# HISTORIC AND DESIGN REVIEW COMMISSION

May 04, 2022

**HDRC CASE NO:** 2022-230  
**ADDRESS:** 910 N PINE ST  
**LEGAL DESCRIPTION:** NCB 1653 BLK A LOT 6  
**ZONING:** R-5, H  
**CITY COUNCIL DIST.:** 2  
**DISTRICT:** Dignowity Hill Historic District  
**APPLICANT:** Michael Long/Long House Builders  
**OWNER:** David Ericsson/ERICSSON DAVID LEE  
**TYPE OF WORK:** Exterior modifications, fenestration modifications, construction of an addition  
**APPLICATION RECEIVED:** April 11, 2022  
**60-DAY REVIEW:** Not applicable due to City Council Emergency Orders  
**CASE MANAGER:** Edward Hall

FLOOR PLAN - BEFORE 1/8"

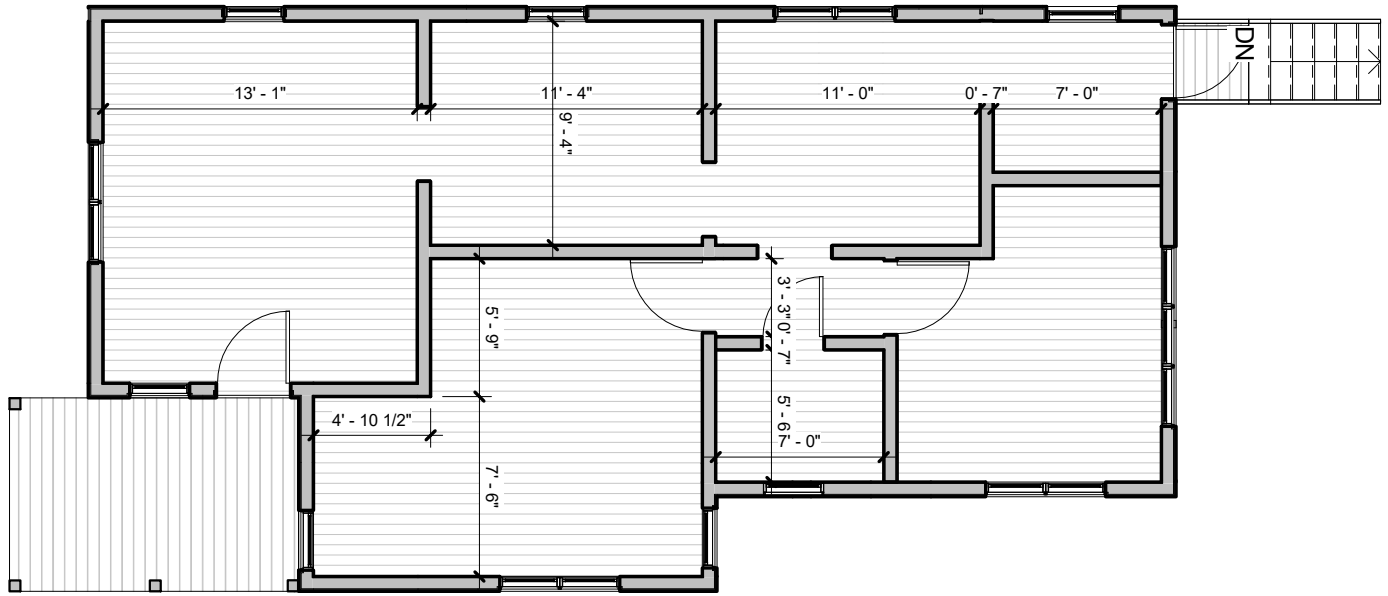
3. Perform fenestration modifications to the north façade including the removal of two grouped windows and the installation of a smaller, singular window, and the installation of two grouped windows in place of a singular window. *(The as built and demolition floor plans do not accurately represent the house as it exists.)*

## 3 SOUTH ELEVATION

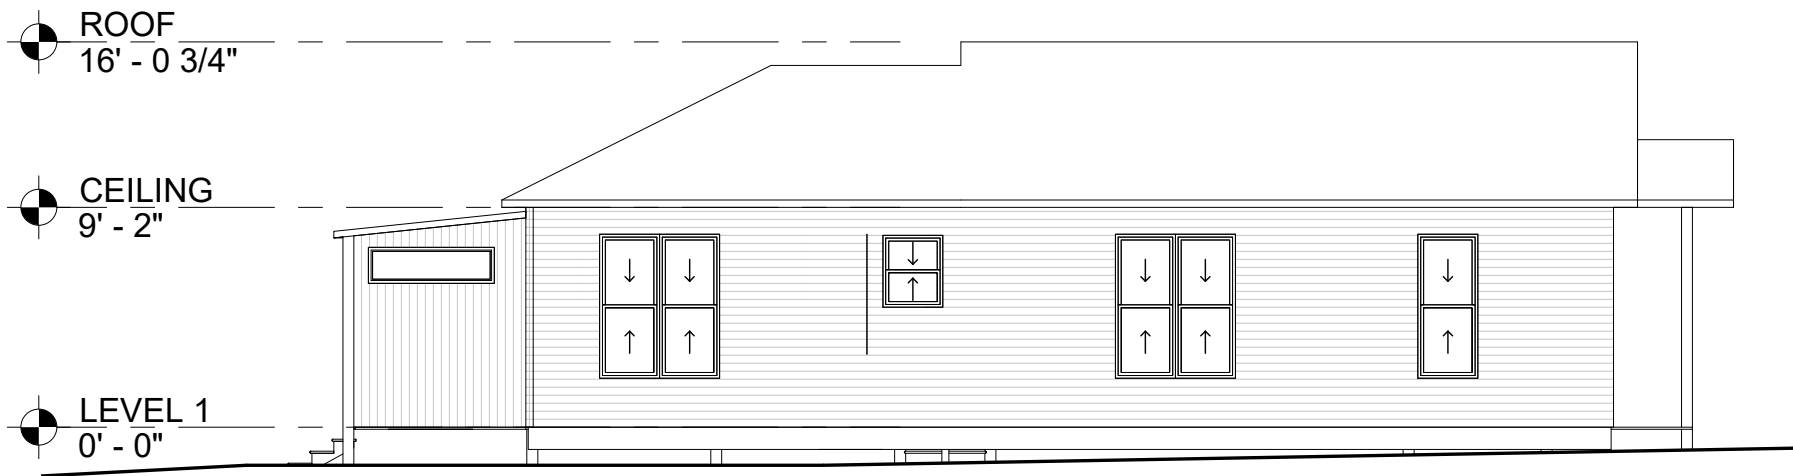
- c. FENESTRATION MODIFICATION (South Façade) – The applicant has proposed to perform fenestration modifications to the south façade including the installation of a group of three windows in place of two windows within the side bay, the removal of three existing window openings to the rear of the side bay, and the installation of a group of three windows and a large, picture window. Per the Guidelines for Exterior Maintenance and Alterations 6.A.i. existing window and door openings should be preserved. Additionally, the Guidelines note that new window openings should not be created on the primary façade or where visible from the public right of way. While in a location visible from the right of way, staff finds that the proposal to install a group of three windows in the side bay is generally consistent with the architectural style. Staff finds that removed wood windows from other locations at the rear of this location should be used, that all windows be separated by mullions, and that the head and sill heights and details match the original. Staff finds the other proposed fenestration modifications to be appropriate as they are not visible from the right of way or are locations impacted proposed rear addition and rear deck construction; however, staff finds that the large picture window should be modified to feature a profile consistent with those found historically within the historic structure.

- d. FENESTRATION MODIFICATIONS (North Façade) – The applicant has proposed to perform fenestration modifications to the north façade including the removal of two grouped windows and the installation of a smaller, singular window, and the installation of two grouped windows in place of a singular window. The as built and demolition floor plans do not accurately represent the house as it exists. Per the Guidelines for Exterior Maintenance and Alterations 6.A.i. existing window and door openings should be preserved. Additionally, the Guidelines note that new window openings should not be created on the primary façade or where visible from the public right of way. Staff finds the modification to a double width window to be appropriate towards the rear of the side façade; however, staff finds that all existing window openings should remain as they exist, including the shorter, grouped windows.

- i. That the large picture window be modified to feature a profile consistent with those found historically within the historic structure.
  - ii. That removed wood windows from other locations at the rear of this location be used in the side bay, and that all windows be separated by mullions, and that the head and sill heights and details match the original.

- 3. Staff recommends approval of item #3 only regarding the installation of an additional window towards the rear of the north façade. Staff recommends that all other window openings remain as they exist. A removed window from another location (from the south façade) should be installed. The windows should be separated by a mullion and the head and sill height should match the original.
